# Planning Committee

<b>Item No:</b> 5.1 and 5.2	<b>Classification:</b> Open	<b>Date:</b> 4 December 2018	<b>Meeting Name:</b> Planning Committee
<b>Report title:</b>		<b>Addendum report</b> Late observations and further information	
<b>Ward(s) or groups affected:</b>		Old Kent Road	
<b>From:</b>		Director of Planning

### Item 5.1 – Application 18/AP/1049 for: Full Planning Application – 78-94 Ornside Street, London SE15 1TF

## **Item 5.2 – Application 17/AP/4819 for: Full Planning Application – LAND AT 313-349 ILBERTON ROAD, LONDON SE15**

# Proposed Basement & Ground Floor Plans

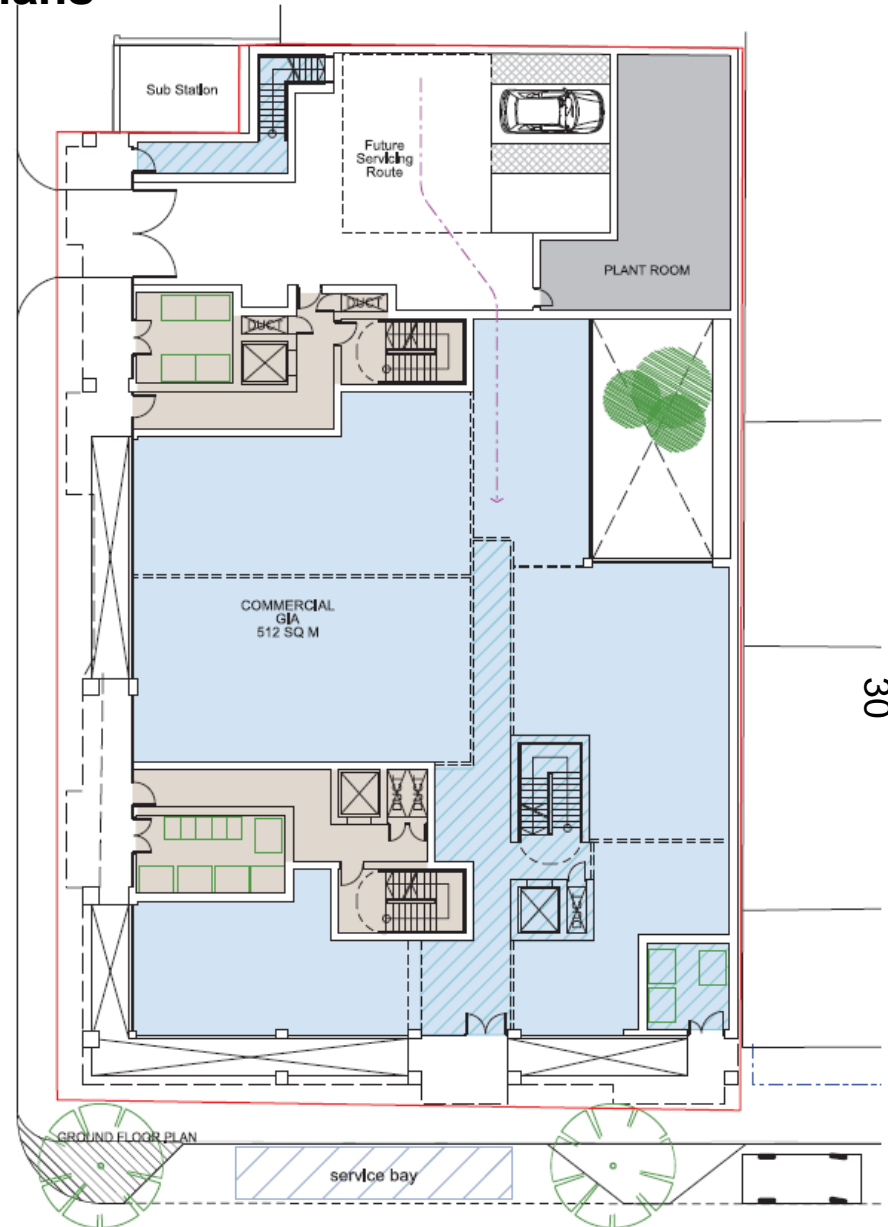
4487/PA/200a - Rev A - ‘Basement Floor & Ground Floor Proposed Plans’ to be corrected to:

4487/PA/200b - Rev B - ‘Basement Floor & Ground Floor Proposed Plans’

# Mezzanine Floor & First Floor Proposed Plans

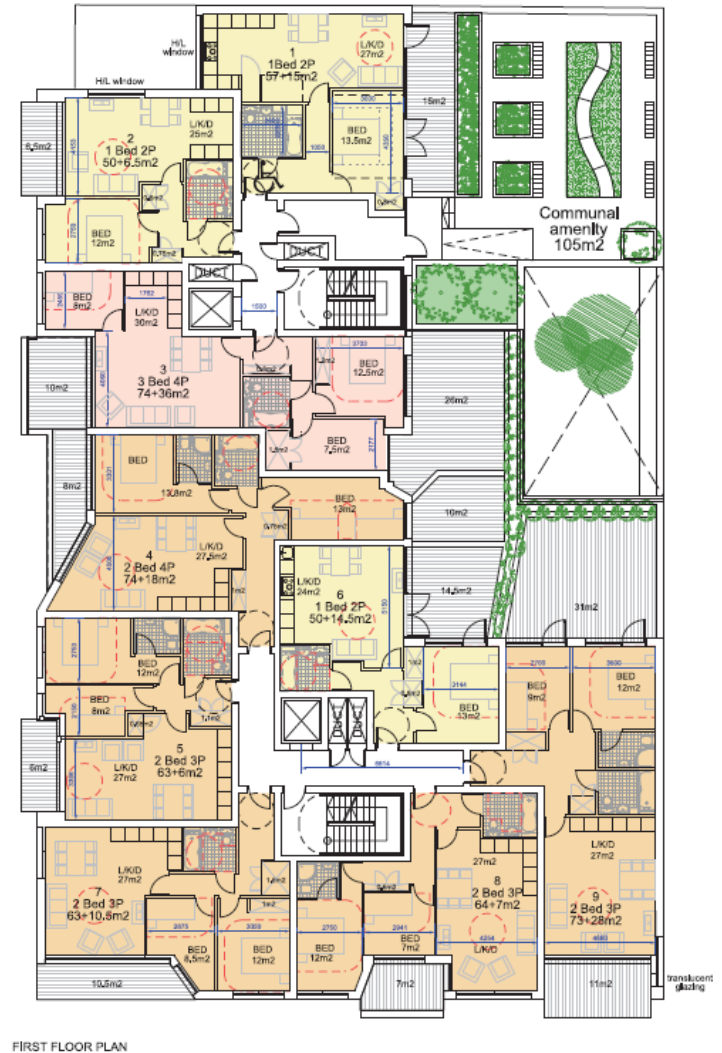
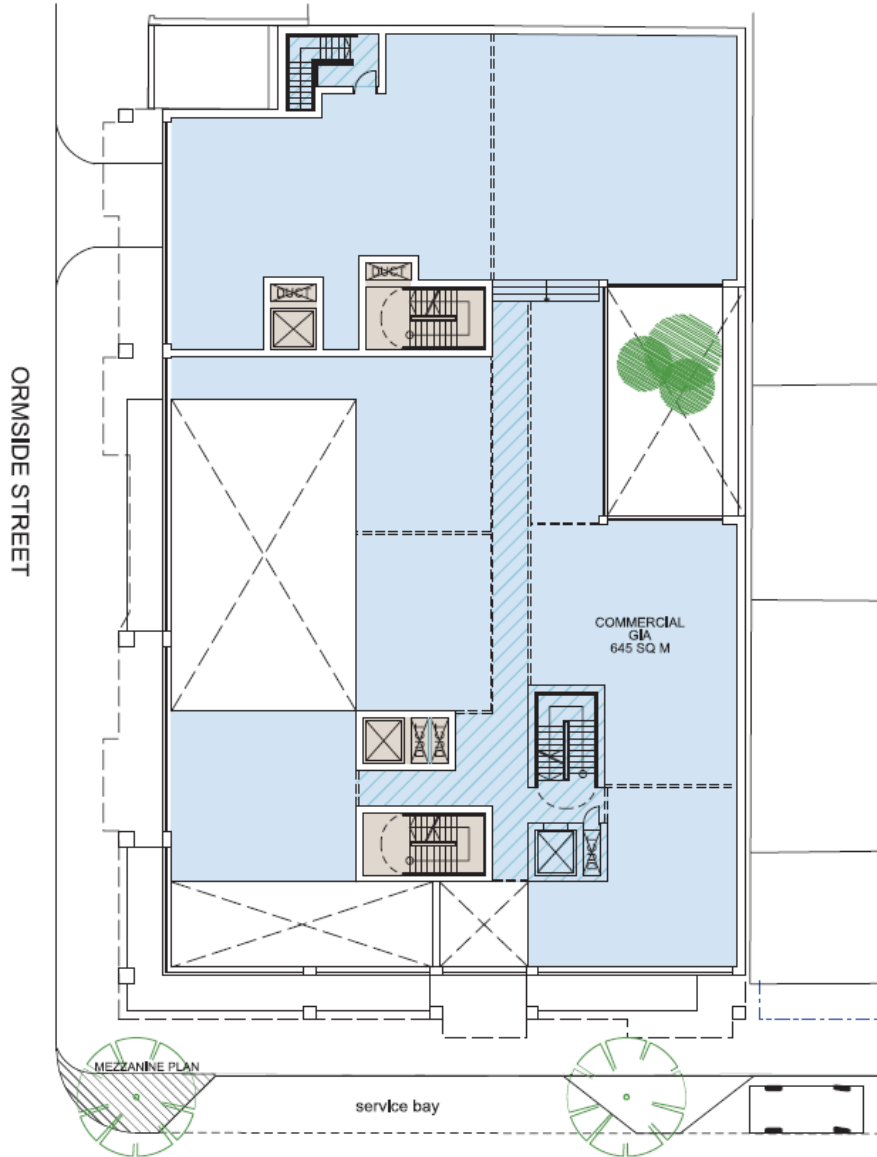
4487/PA/201a - Rev A - ‘Mezzanine Floor & First Floor Proposed Plans’ to be corrected to:

4487/PA/201b - Rev B - ‘Mezzanine Floor & First Floor Proposed Plans’
